**PREVOST**

**SAFETY  
RECALL**

**SR21-12**

DATE:	December 2021	SECTION: 18 BODY
SUBJECT:	<b>SECURING LOOSE CEILING PANEL</b>

Figure 1

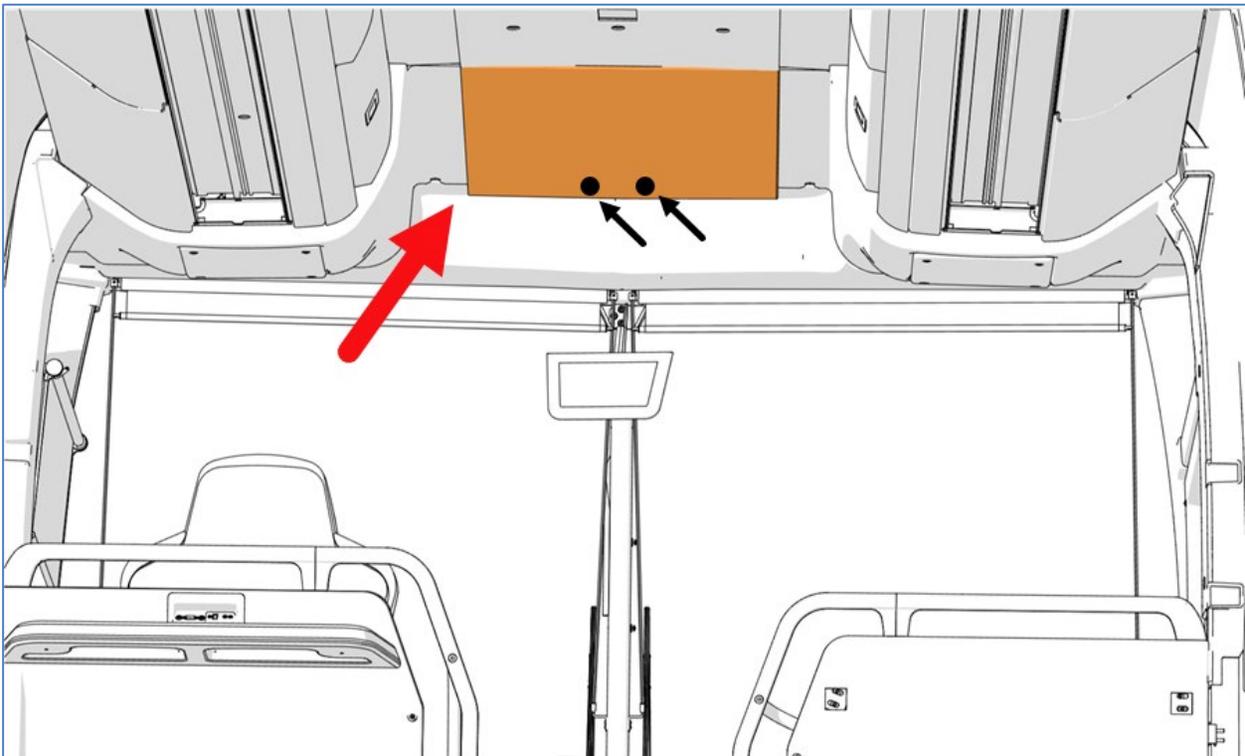
1. Locate the ceiling panel which needs to be secured at the front of the vehicle, over the central aisle.

Figure 2

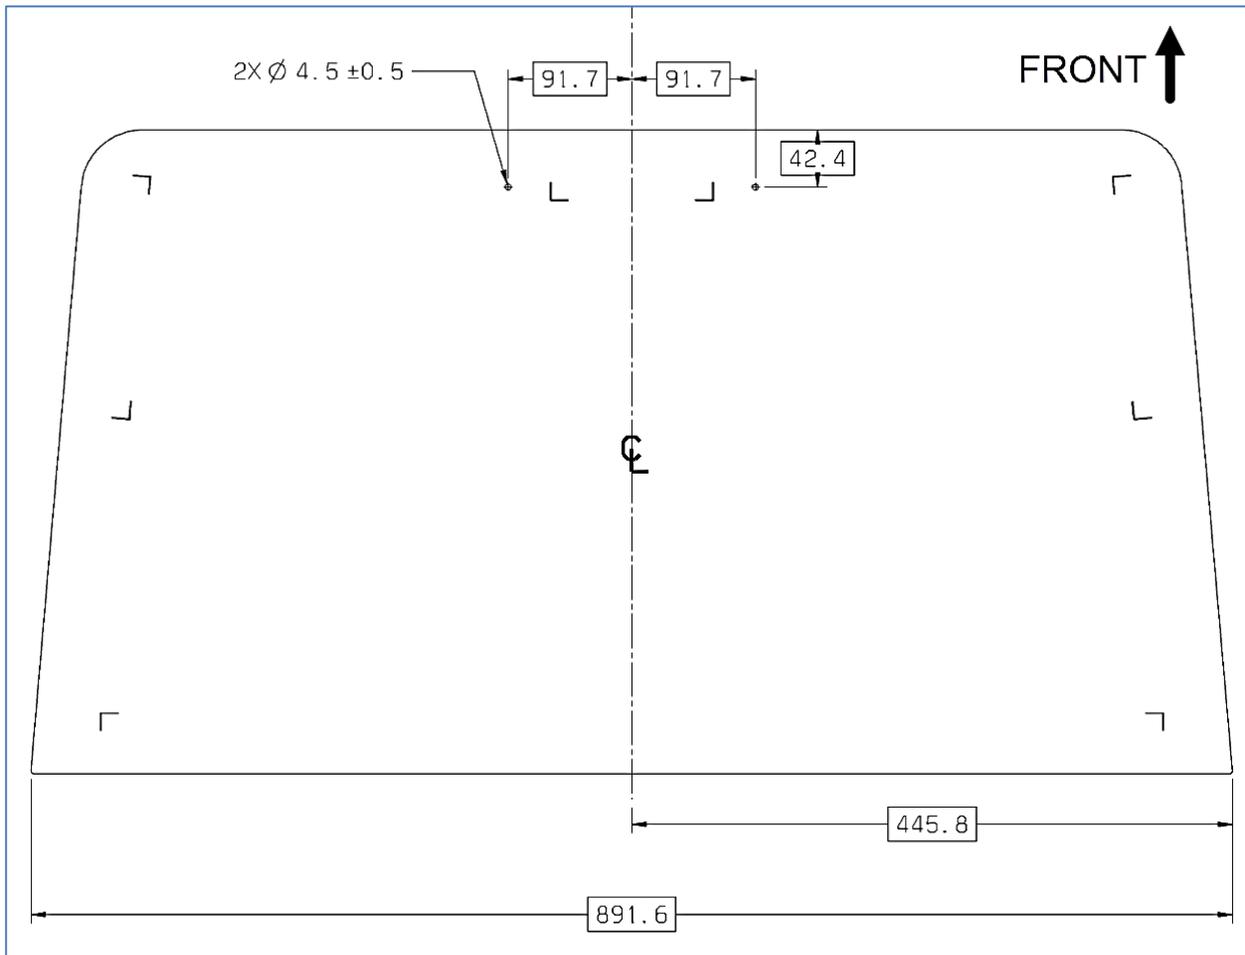
2. Mark two drillings position in accordance with the following image (dimension in millimeters).

91.7 mm = 3.610 inches

42.4 mm = 1.669 inches

445.8 mm = 17.551 inches

891.6 mm = 35.1 inches
